Access Compliance Report

Public Rights-of-Way

(Curb Ramps)

Intersection ID: 24384	Main Street: BIRNEN_DR	Cross Street: N_VICKSBURG_PARK_CT	Location: S
ADA ID: 54766C0A693B	Ramp Type: BlendTrans2	Initial Pass/Fail: Fail	Overall Compliance: No
Severity Score: 8.75			
Codes/Mitigation Info/Possible Solution		Field Measurements/Component Compliance

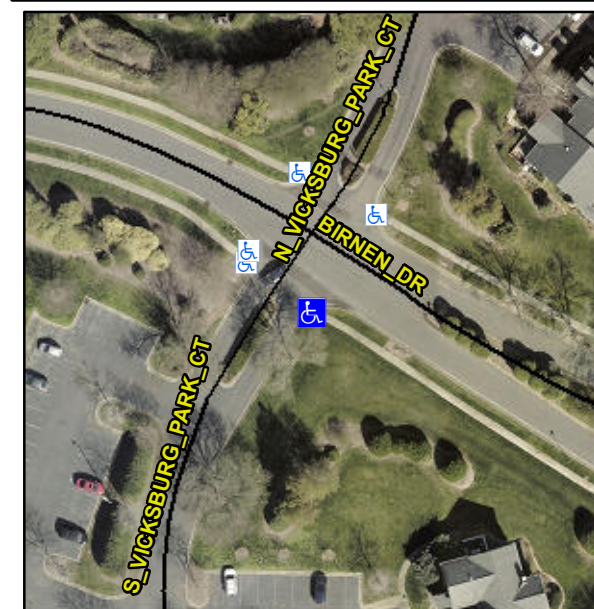
NO LNDG

Not Found, R304.5.1

Compliance	Description	Data	Compliance	Description	Data
N/A	Ramp Length (in)	47.0	Yes	BlendTrans Slope (%)	3.8
No	Ramp Width (in)	47.0	Yes	BlendTrans XSlope (%)	1.1
N/A	Flare Type LT	N/A	N/A	Flare Type RT	N/A
N/A	Flare Slope LT (%)	N/A	N/A	Flare Slope RT (%)	N/A
N/A	Flare Traversable LT?	N/A	N/A	Flare Traversable RT?	N/A
N/A	Landing Length (in)	N/A	N/A	DWS Provided?	N/A
N/A	Landing Width (in)	N/A	N/A	DWS Contrast?	N/A
N/A	Landing Slope (%)	N/A	N/A	DWS Length (in)	N/A
N/A	Landing X Slope (%)	N/A	N/A	DWS Full Width?	N/A
N/A	Landing Curb? (Y/N)	N/A	N/A	DWS Offset (in)	N/A
N/A	Shared Landing?	N/A			
N/A	Gutter Ponding?	N/A	N/A	Gutter Slope (%)	N/A
N/A	Gutter Lip Ht (in)	N/A	N/A	Gutter X Slope (%)	N/A
N/A	Painted X Walk1?	No	N/A	Painted X Walk2?	No
	X Walk 1 Direction	To NE		X Walk 2 Direction	To NW
	X Walk 1 Width (in)	N/A		X Walk 2 Width (in)	N/A
	X Walk 1 Slope (%)	2.2		X Walk 2 Slope (%)	0.4
	X Walk 1 X Slope (%)	0.9		X Walk 2 X Slope (%)	0.8

N/A	Ramp inside XWalk1?	N/A	N/A	Ramp inside XWalk2?	N/A
	Road Slope (%)	2.2		Clear Space?	N/A
	Road X Slope (%)	1.2	N/A	Clear Space to XWalk (in)	N/A
N/A	Any Obstructions?	N/A	N/A	Storm Grate/Utility Hazard?	N/A
	Obstruction Type			Storm Grate/Utility Type	
		N/A			N/A
			Yes	Surface Condition? (G/P)	Good
			No	Curb Slope (%)	6.6

Remove & Replace Curb Ramp With Two New Directional Ramps or Equivalent.
